Re: Interpretation for RZ/FDP 2003-BR-012
Chandler Grove: retaining walls

Re: Pending Interpretation for "Chandler Grove"
RZ/FDP 2003-BR-012
Follow Up to Letter of March 16, 2005

CHANDLER GROVE

NORTH RETAINING WALL

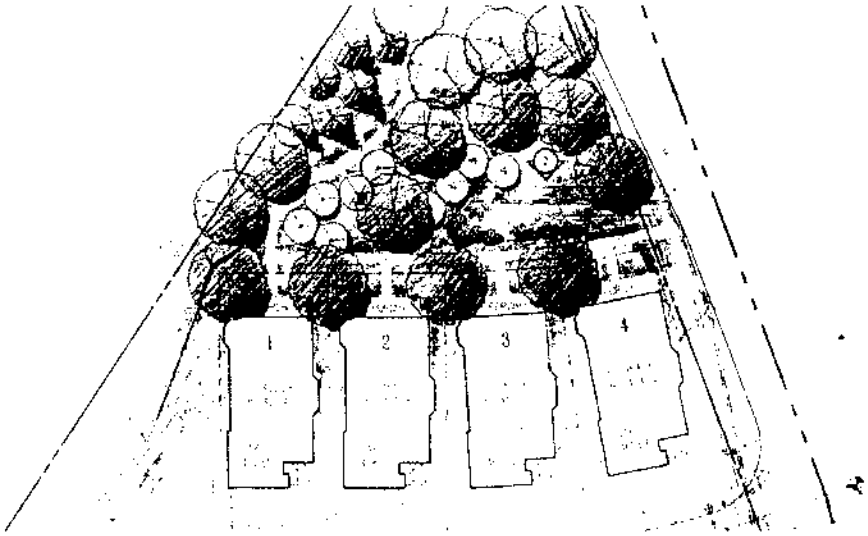
Northern Retaining Walls
In meetings on this request, you indicated that the retaining walls in the northern end of the property are necessary in order to tie into the grade along Rust Road and to protect trees in the tree save area along the western boundary. In your May 3, 2005, letter, you noted that neither section of wall is in excess of 4 feet tall, and, as opposed to earlier exhibits, that the walls will not block the direct access to the open space area for the majority of the units. It is my

determination that the proposed retaining walls in the northern portion of the site, as shown on the attached exhibits, are in substantial conformance with the CDP/FDP.

Compared to the original interpretation request, the retaining wall previously proposed to run in an east west direction across the northern portion of the site just south of the open space area has largely been removed. As shown on the attached materials, the only walls remaining in this general area are where the site transitions to Rust Road directly along the eastern boundary of the property and in the area adjacent to the tree save area on the western boundary. As represented in our meeting yesterday, each of these walls has a maximum height of less that 4 feet.

SOUTH RETAINING WALL

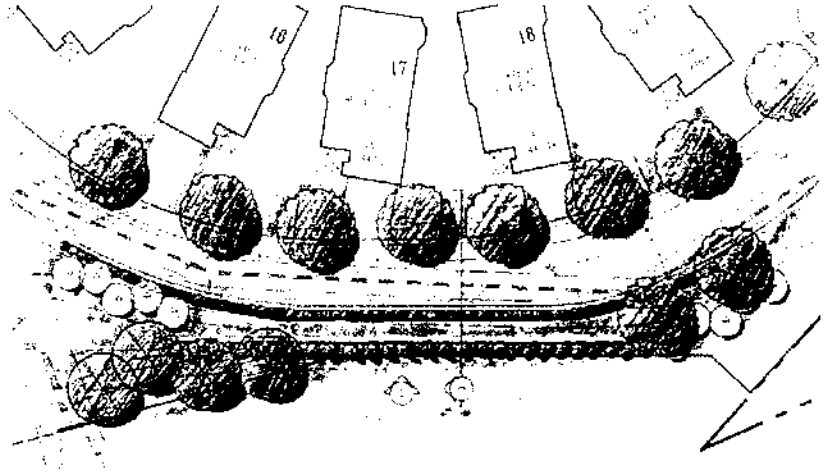
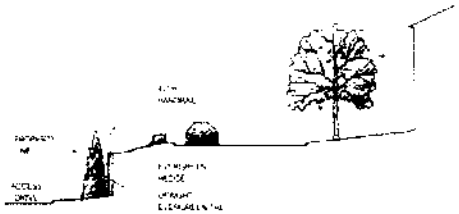
Southern Retaining Walls
In your letters, you indicate that the retaining wall along the southern property line is necessary in order to maintain the limits of clearing and grading shown on the CDP/FDP. In order to maintain an area of landscaping along the southern property line, you have reduced the number of lots by one (from 25 units to 24 units) and moved the road and the wall further into your site. This results in a distance between the proposed road and the top of the wall of approximately 10 feet, and a distance between the base of the wall and the property boundary of approximately 5 feet. You have indicated that the major open space amenity of the site (labeled as the "Village Green") has not been reduced in size, and the overall open space in the development has slightly increased. Finally, you have indicated that the proposed landscaping at the base of the wall (adjacent to Park Authority property) will be defined and installed in consultation with the Park Authority, and that the maintenance obligation of the Homeowners' Association for this landscaping will be included in the HOA documents. The wall itself has a length of approximately 170 feet, a maximum height of 7.8 feet, and a 42" fence/handrail along the top. It is my determination that the proposed retaining wall in the southern portion of the site, as shown on the attached exhibits and with the parameters discussed here, is in substantial conformance with the CDP/FDP.

Along the southern boundary of the property, significant changes have been made in the height, location, design and configuration of the retaining wall. In response to comments from both the Planning staff and Park Authority, the maximum height of the wall has been reduced from as high as 14 feet to approximately 7.8 feet. Reflective of the site's topographic conditions, the height of the wall tapers down in an east west direction as generally shown on the attached exhibits. Of equal significance, the wall has been relocated away from the southern property line. This strategic relocation provides new opportunities for landscaping that is detailed on the attached materials. It is the developer's intention to screen the visible portions of the wall with evergreen or other plantings. We have no objection to the final plantings being approved by both the Urban Forestry Division and the Park Authority.

In terms of materials and design, all of the retaining walls are proposed to be constructed of the "Rockwood" type materials presented on the attached drawings. As we discussed in detail yesterday, for the larger retaining wall on the southern boundary of the property, it is the developer's intention to use a grey colored masonry material. We believe this will blend in best with both the proposed landscaping and that the vegetation that exists on the adjacent Park Authority property.
